**AEC DISTRIBUTION FOR PART 50 DOCKET MATERIAL
(TEMPORARY FORM)**

PLANT NAME: Cook 1 & 2

Enclosed are copies of letters sent to Mr. Donald F. Knuth, Director, Directorate of Regulatory Operations, on December 20, 1974. These letters addressed deficiencies in coils on certain Westinghouse relays and improper wiring of the Foxboro Reactor Protection System on-line test panel.

The equipment deficiency has been identified as improper wiring of the Foxboro Reactor Protection System on-line test panel. This equipment is supplied by Westinghouse. This deficiency was reported by Mr. R. S. Hunter, Vice President, Nuclear Engineering, American Electric Power Service Corporation, to Mr. Cecil Jones in a telephone conversation on December 2, 1974.

FIGURE 1

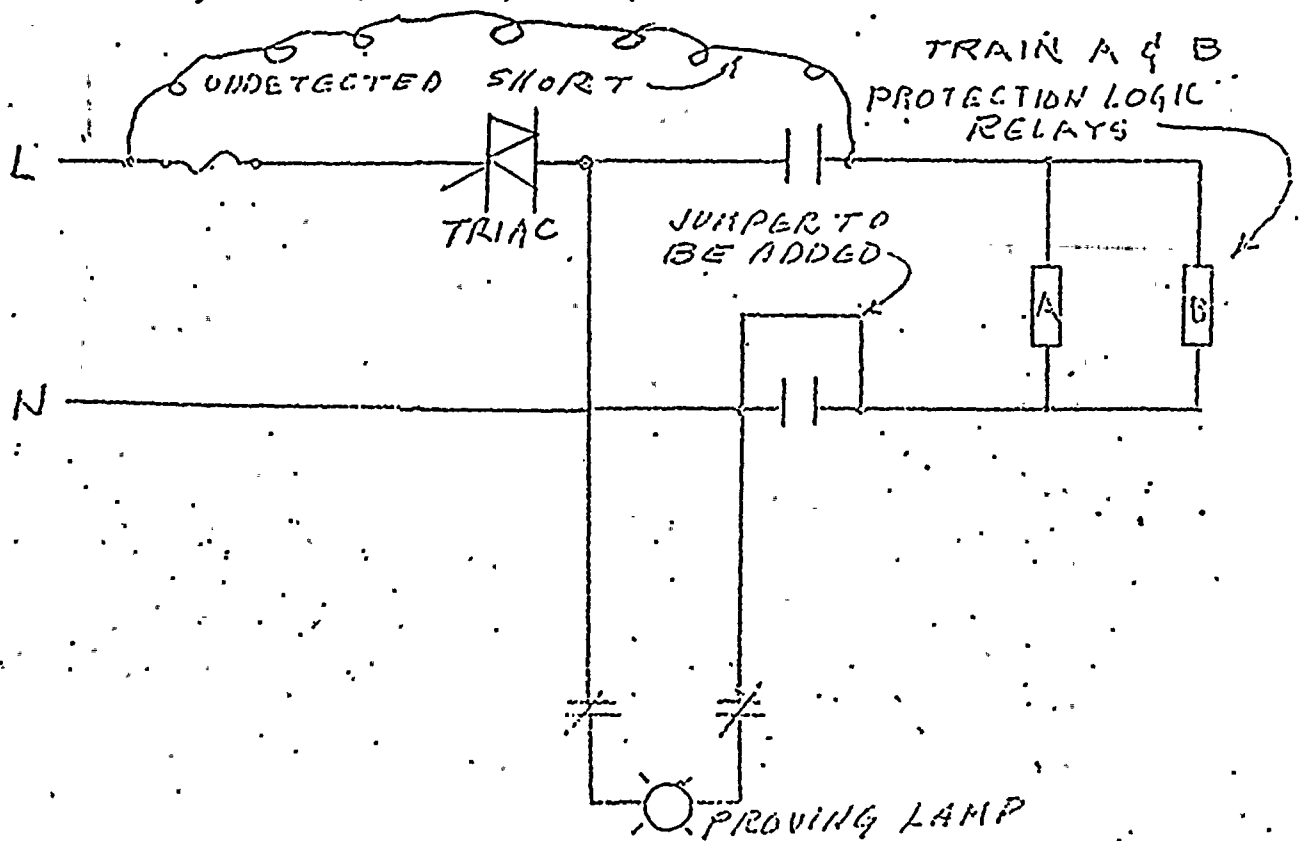
The difficulty arose because the bistable (comparator) output test switches used are double pole and, therefore, break both sides of the output to the load while the bistables only break one side. Therefore, certain types of short circuits could remain undetected. As can be seen in Figure 1, a short circuit which shunts the bistable switching element and the switch contact is undetected. This is true because the return line is opened. Thus

even though a short circuit existed the status lights would operate normally during the test and yet the channel could not generate a valid trip signal.

To preclude the possibility of such short circuits remaining undetected, jumpers were added within the test panel, one for each bistable test switch as shown on the attached sketch. The purpose of these jumpers is to short cut the pole on the test switch that is not in series with the bistable element so that the operation of the channel while in test exactly simulates the operation of the channel under normal operating conditions.
